ADDRESSEES	: Owners and operators ABC Customer Care and Parts Source
VEHICLE MODEL	: TD925US
MANUAL SECTION	: 14.10 Electricity – wiring
BULLETIN TYPE	: Field Change Program
DATE	: December 09th, 2019
SUBJECT	: To optimize power supply of fuse holder ZB3 in junction box EKA
TERMS & CONDITIONS	: Refer to the warranty section further in this Bulletin.

Figure 1: In luggage compartment, location of concerned 6mm² power supply wire on grid panel of junction box “Vanner (orientation of Vanner and grid panel may vary)

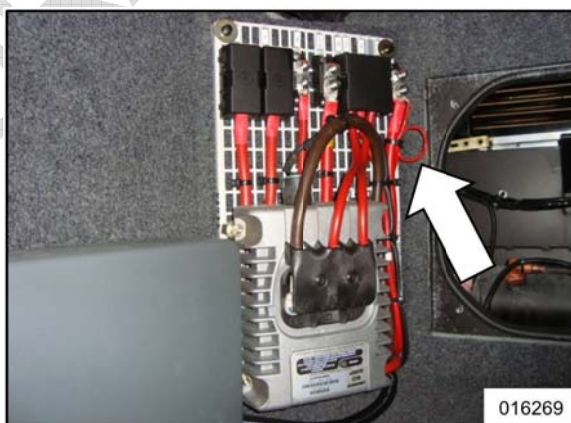
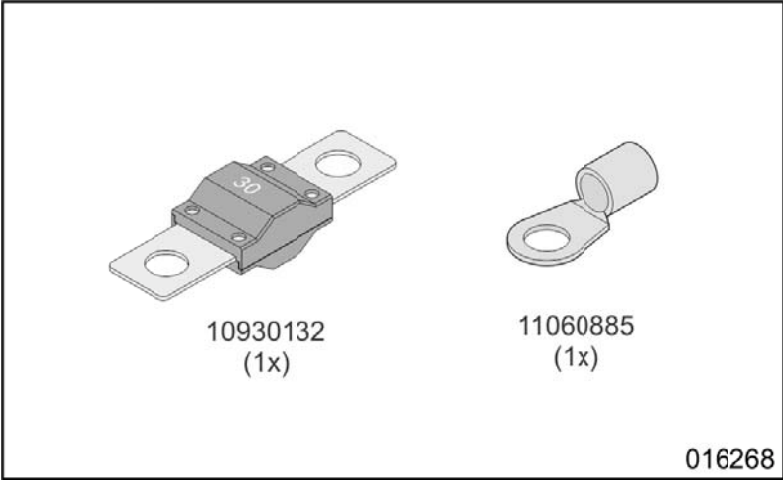
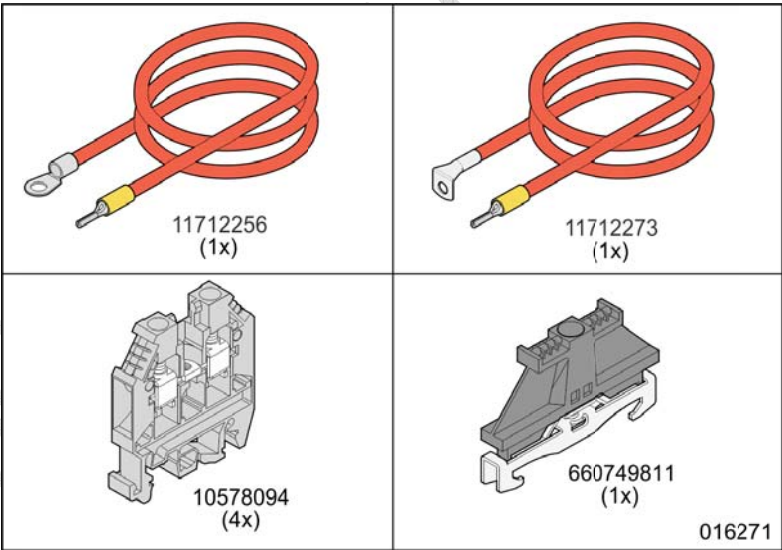
It has been reported that the red 6 mm² power supply wire connected at stud “MP+24V” in junction box “Vanner” is not protected by a fuse. This wire runs from stud “MP+24V” to terminal block DVB in junction box EKA, from there the wire continues to fuse holder ZB3 in junction box EKA to power fuses Z83.1 and Z86.

This service bulletin gives step-by-step instructions how to install an additional 30A MIDI-fuse in junction box “Vanner” to make sure that this wire is protected against overheating in case of overcurrent.
